### 3/4.2.6 POWER/FLOW INSTABILITY

Predicated on the SIL 380 endorsement, WNP-2 has divided the power/flow map on the following boundary lines:

## PLANT PROCESS COMPUTER REPLACEMENT SYSTEM (PPCRS) OVERVIEW

Operating Region Limits of Specification 3.2.6  
Figure 3.2.6-1

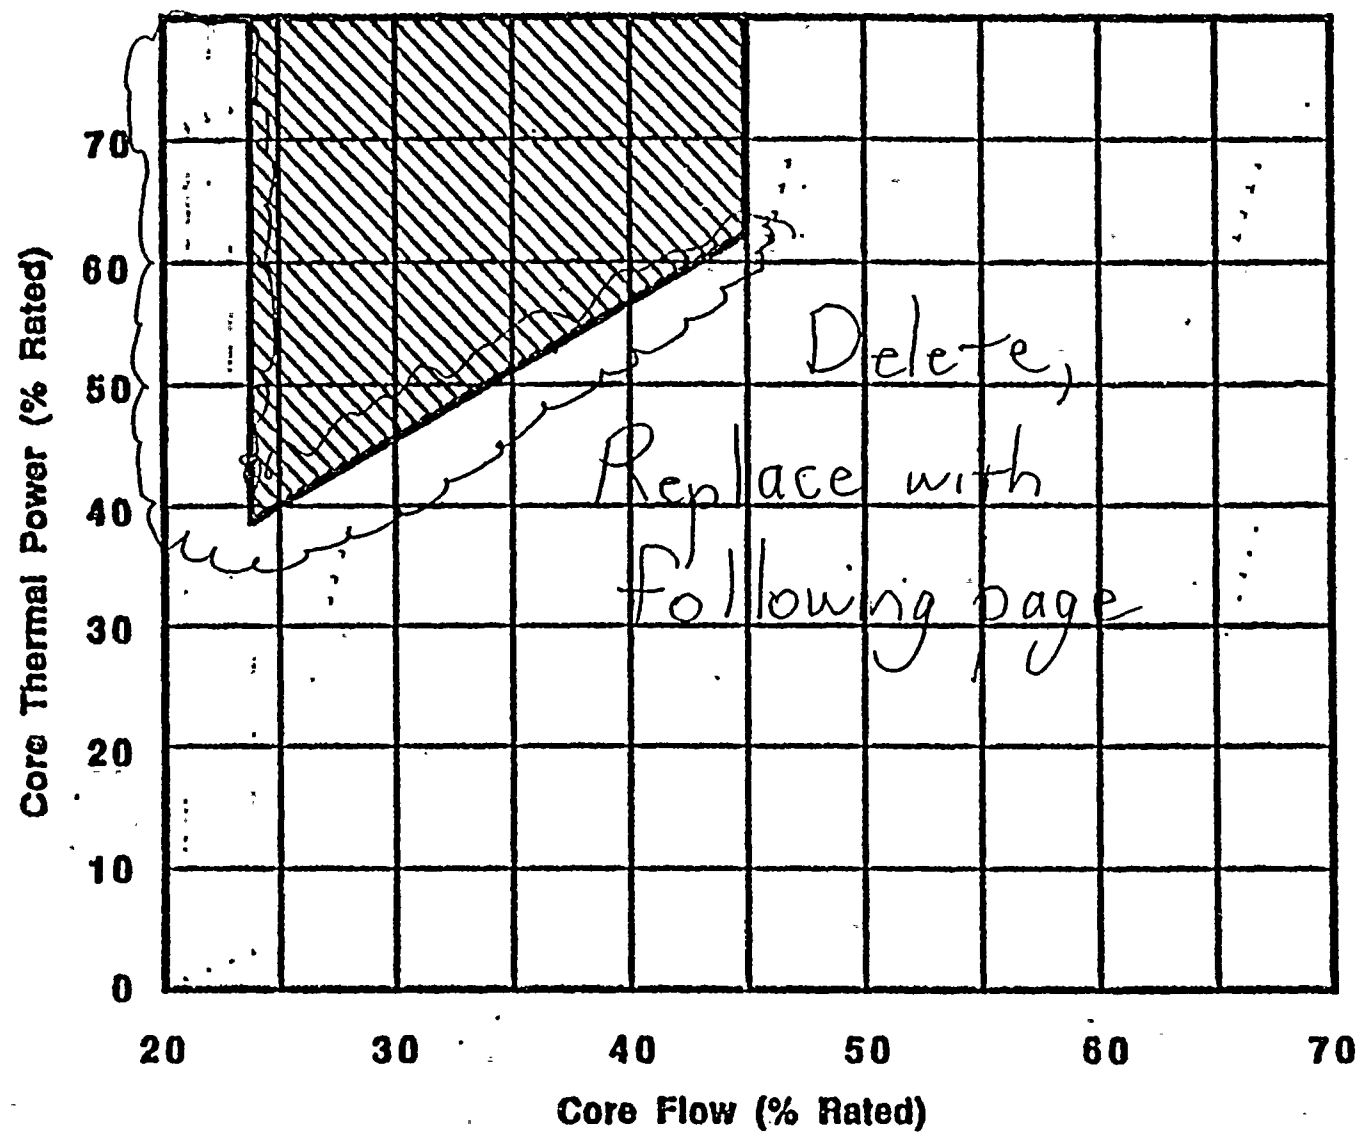
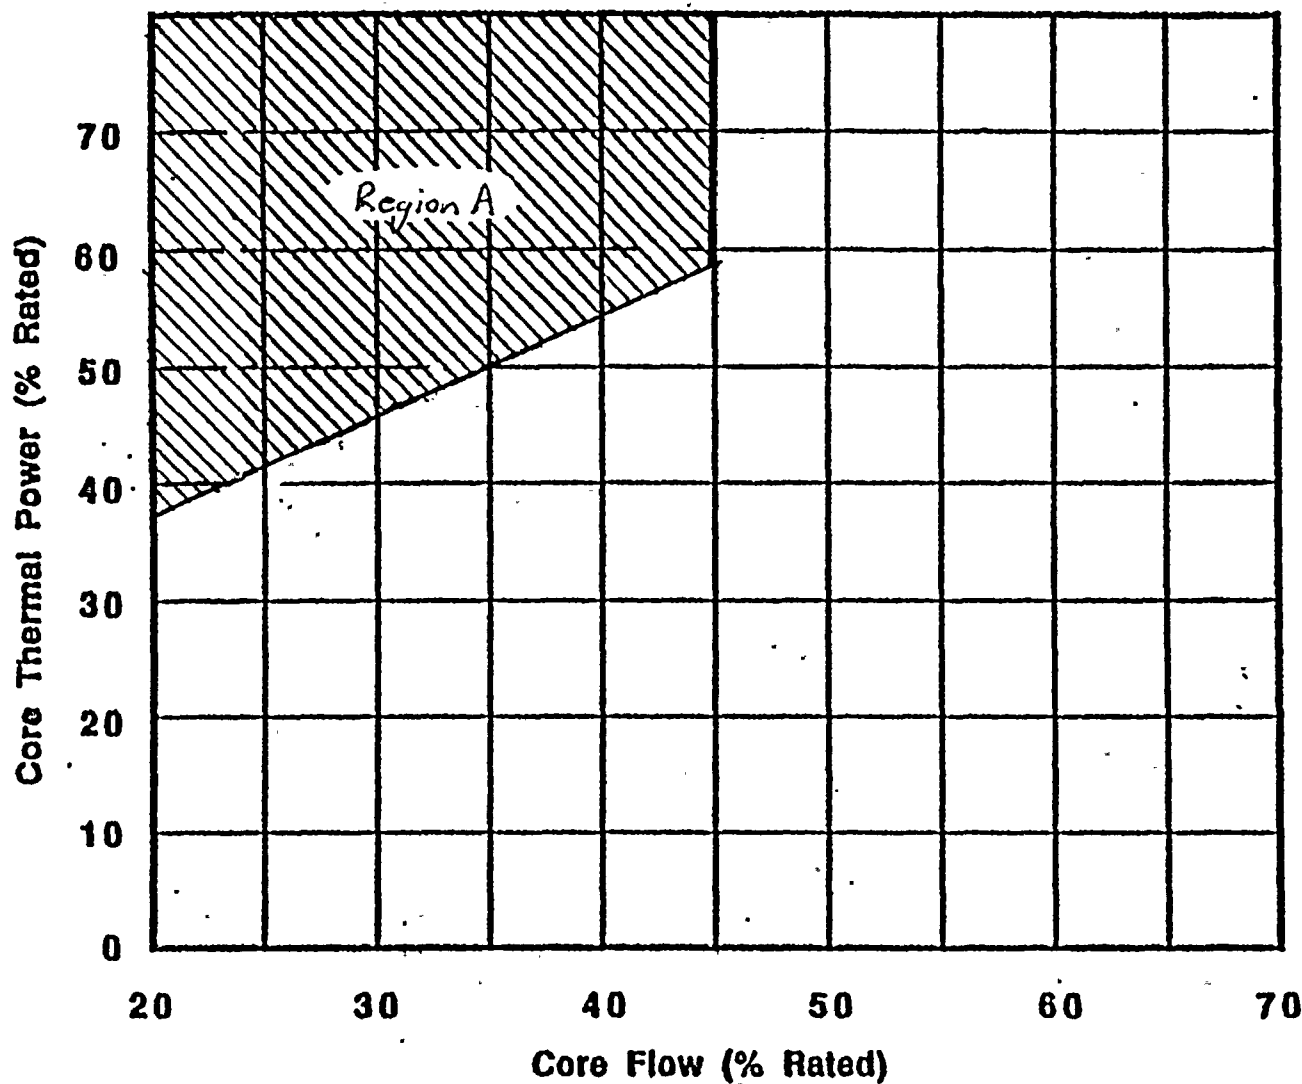
3.2.6 Operation with THERMAL POWER/core flow conditions which lay in ~~the~~ *Region A* crosshatched region of Figure 3.2.6-1 is prohibited.

With THERMAL <sup>*Region A*</sup> POWER/core flow conditions which lay in the ~~crosshatched~~ region of Figure 3.2.6-1, initiate ~~corrective action within 15 minutes to establish a~~ THERMAL POWER/core flow condition which lays outside the crosshatched region within ~~2 hours~~. A MANUAL SCRAM.

4.2.6 The THERMAL POWER/core flow conditions shall be verified to lay outside *Region A* ~~the crosshatched~~ region of Figure 3.2.6-1 once per 24 hours ~~x~~ when operating in the region of APPLICABILITY.

Operating Region Limits of Specification 3.2.7<sup>8</sup>  
Figure 3.2.7-1<sup>8</sup>

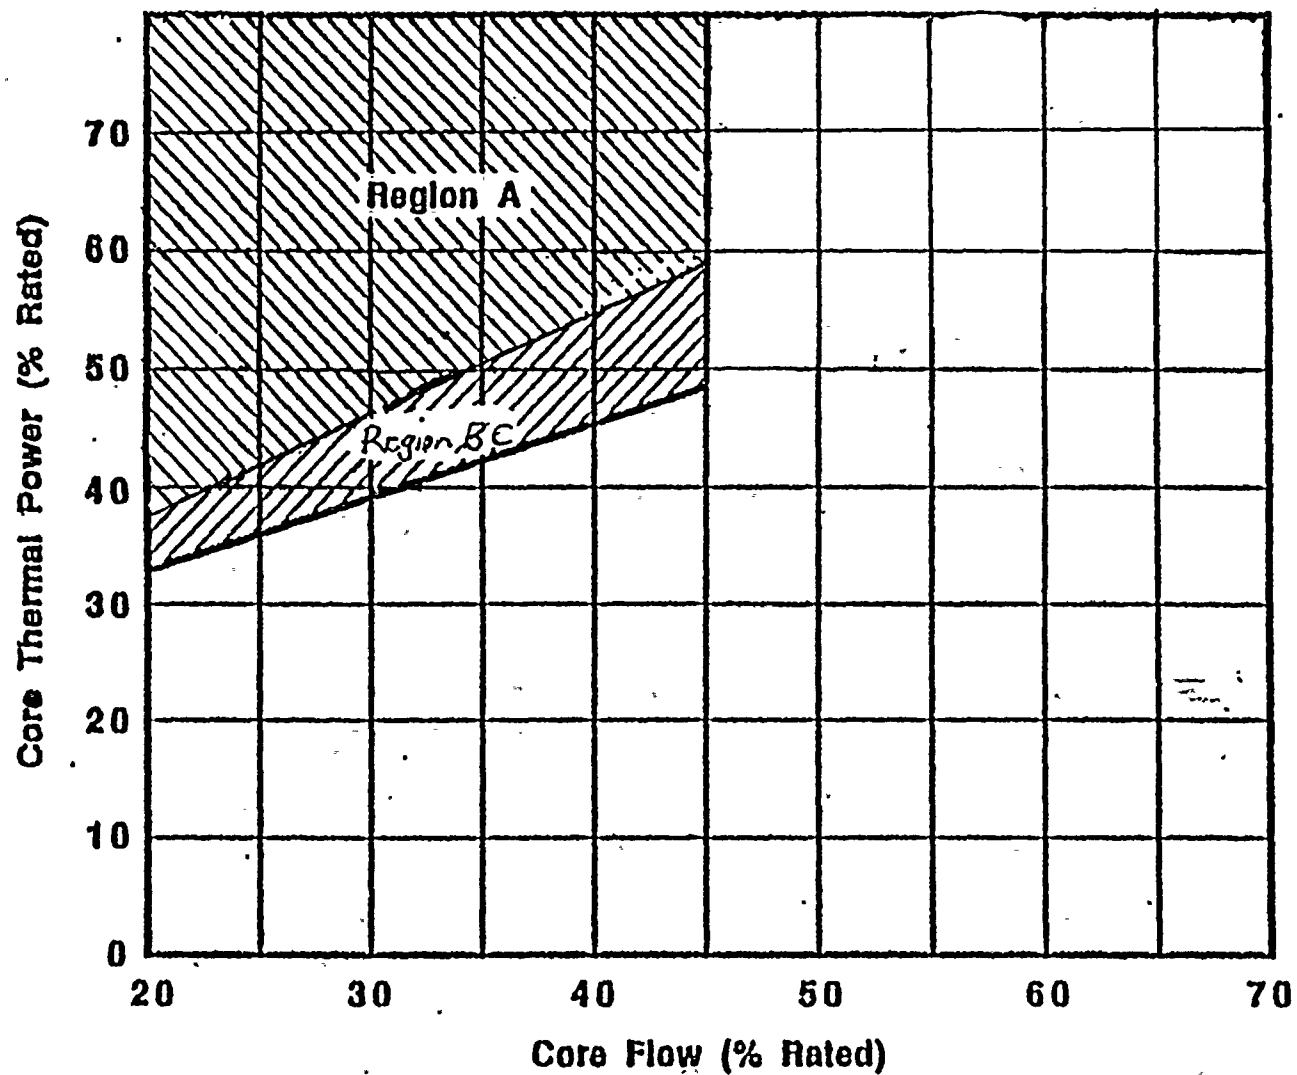
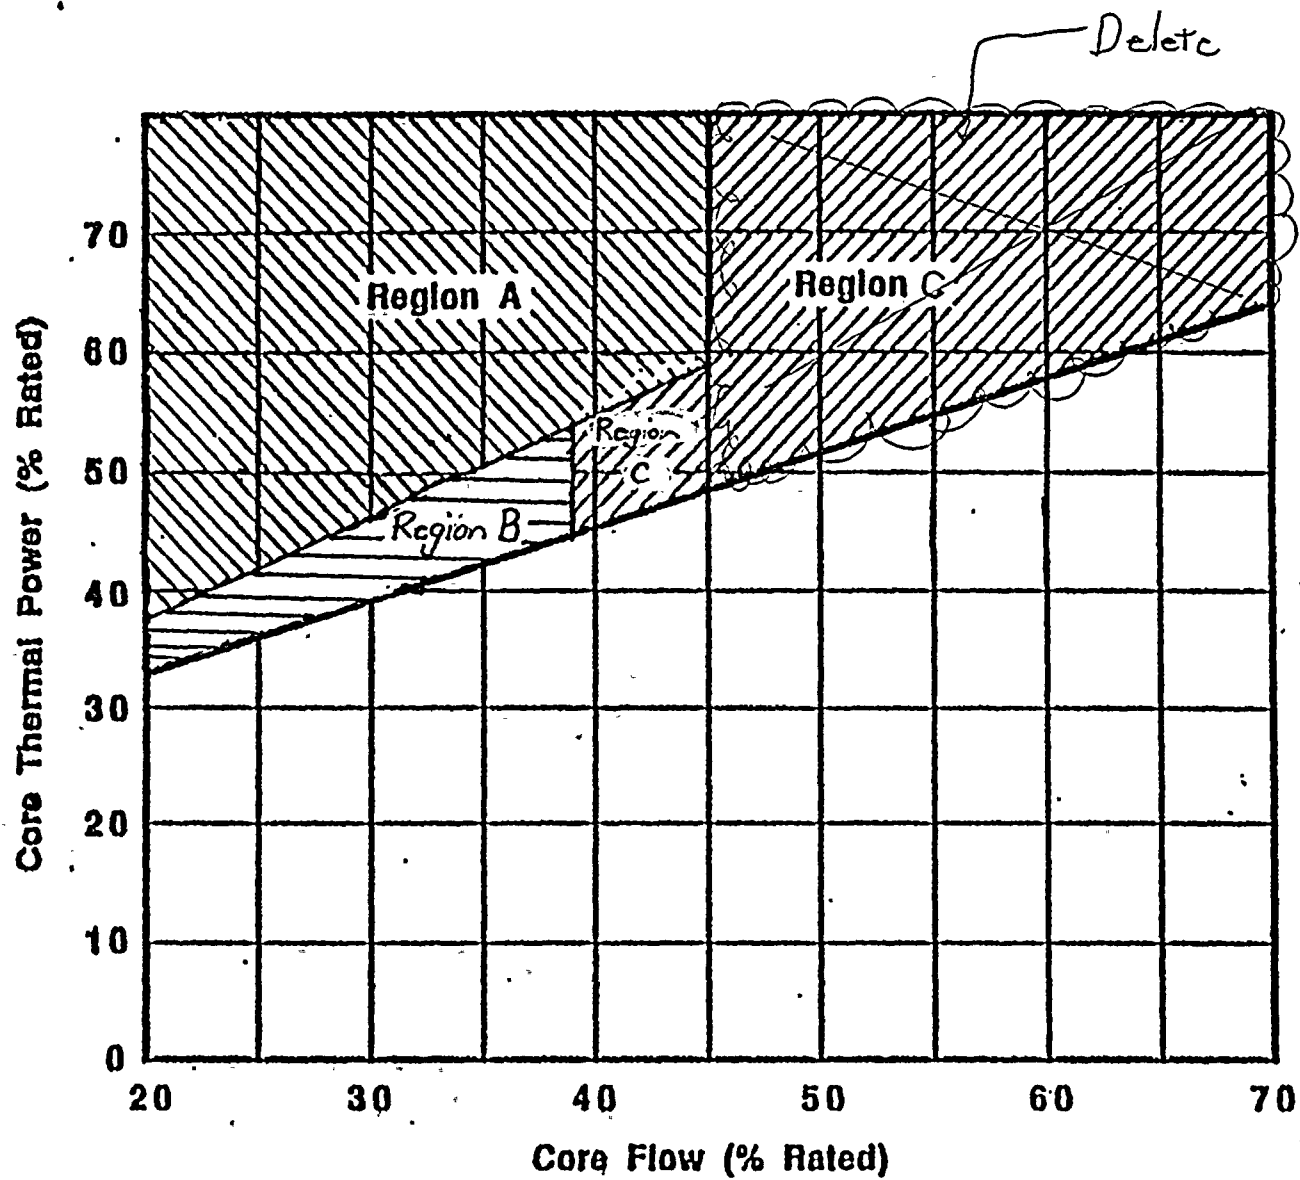
APPLICABILITY: OPERATIONAL CONDITION 1, with two recirculation loops in operation and THERMAL POWER/core flow conditions which lay in Region B' of Figure 3.2.7-1 <sup>C</sup>

Delete, Replace with following page

Operating Region Limits of Specification 3.4.1.1  
Figure 3.4.1.1-1

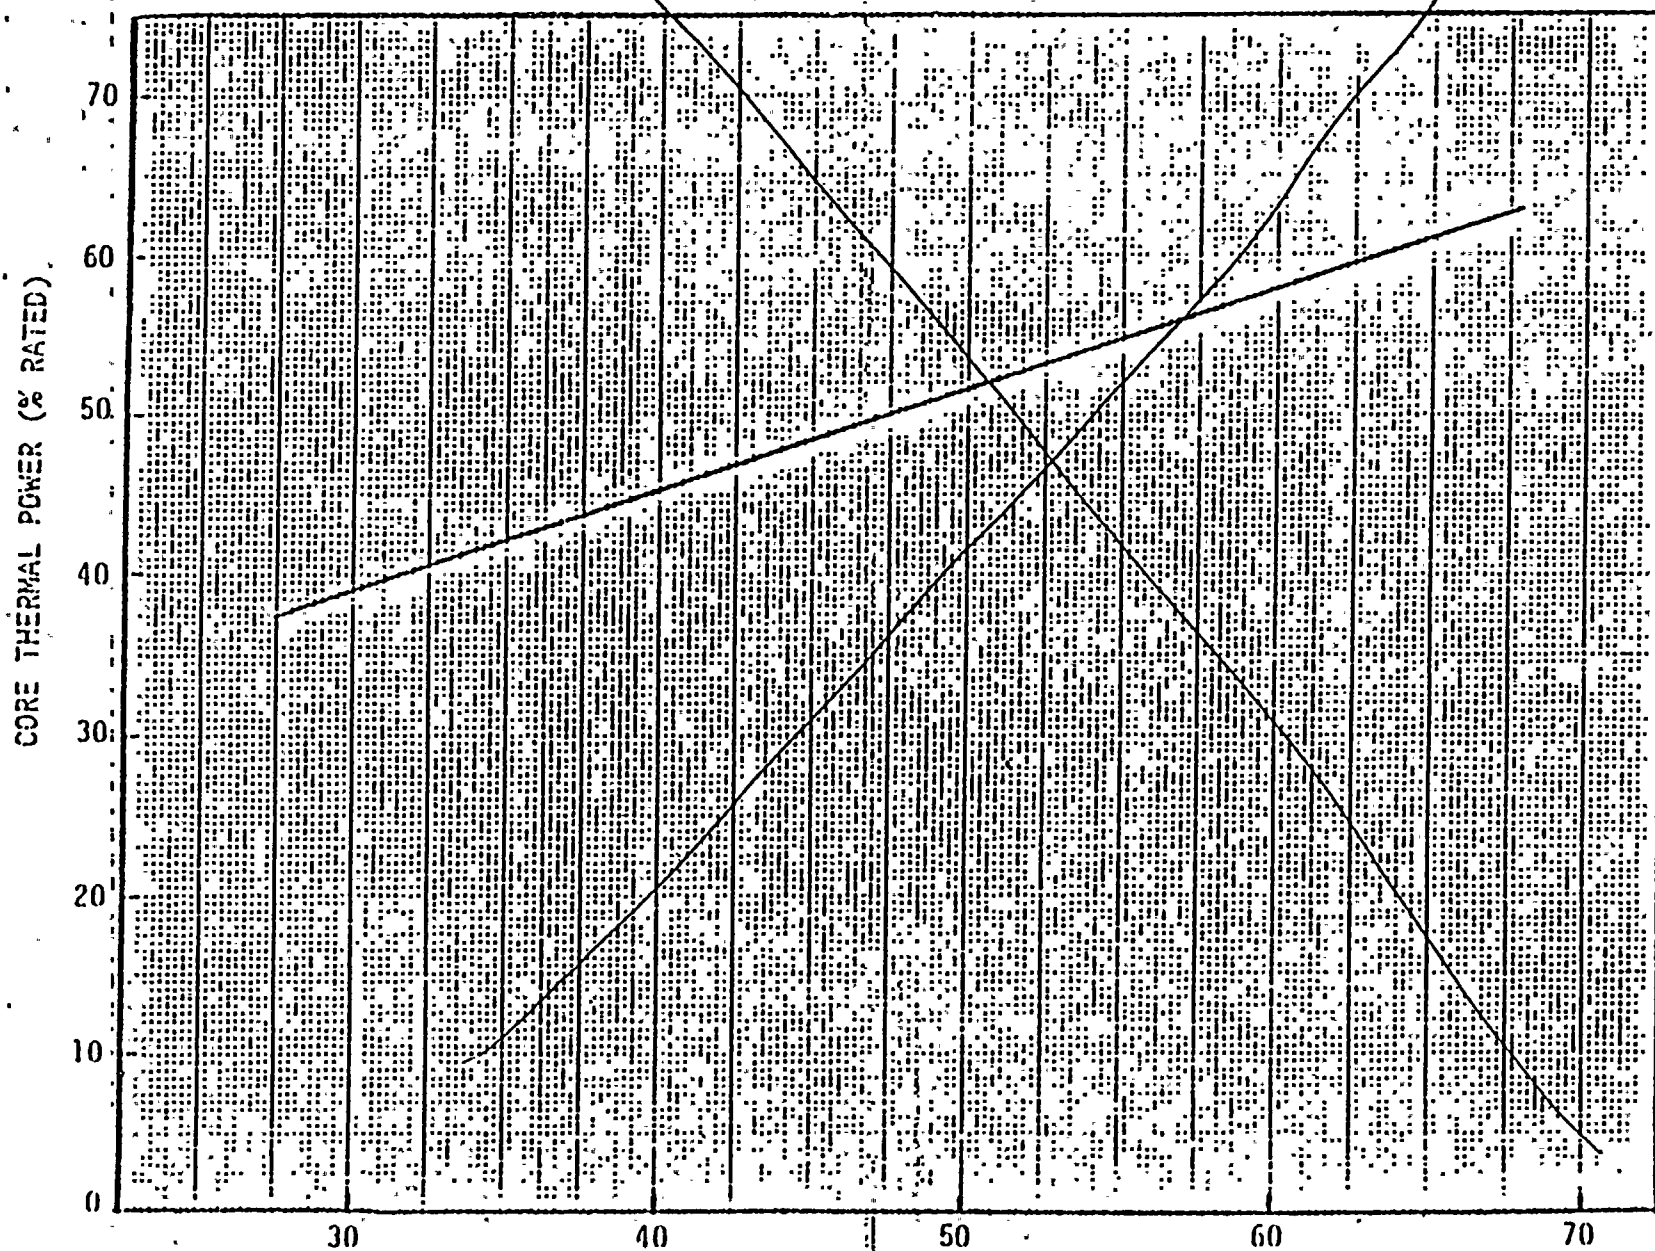
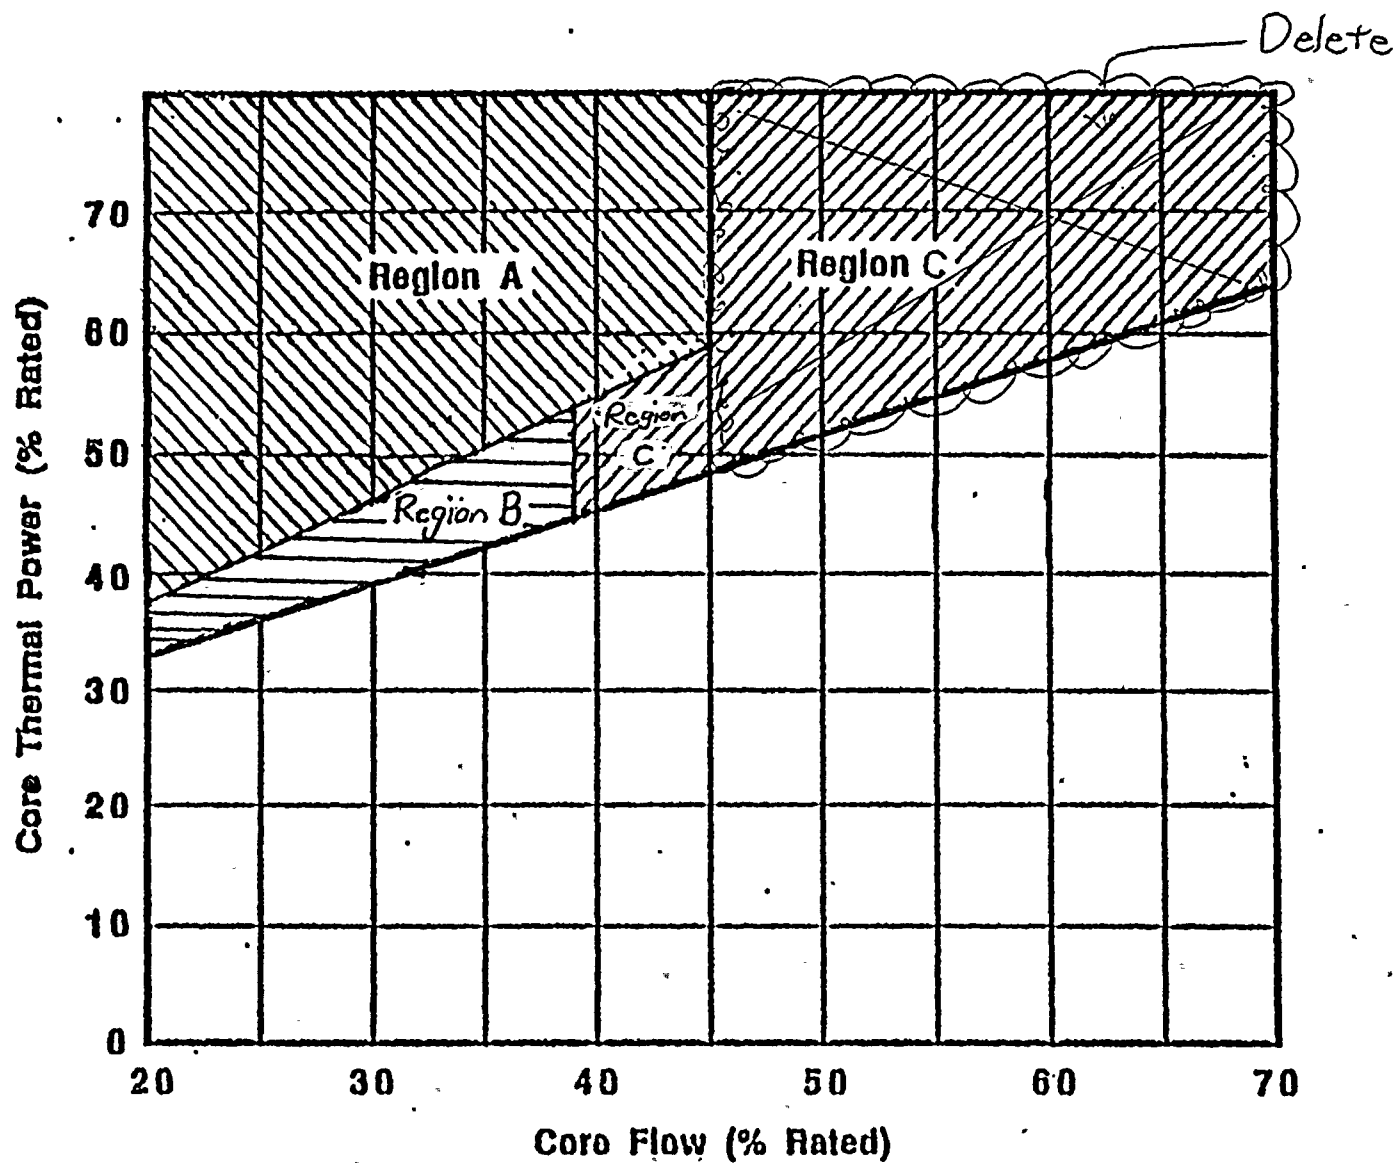
2. Verify that THERMAL POWER/core flow conditions lay outside Region B of Figure 3.4.1.1-1.

*as soon as practical, but in all cases within 15 minutes,*  
With THERMAL POWER/core flow conditions which lay in Region B of Figure 3.4.1.1-1, ~~IMMEDIATELY~~ initiate action to exit Region B by either decreasing THERMAL POWER with control rod insertion or increasing core flow with flow control valve manipulation. Within 1 hour exit Region B. The starting or shifting of a recirculation pump for the purpose of exiting Region B is specifically prohibited.

Delete,  
Replace w following page
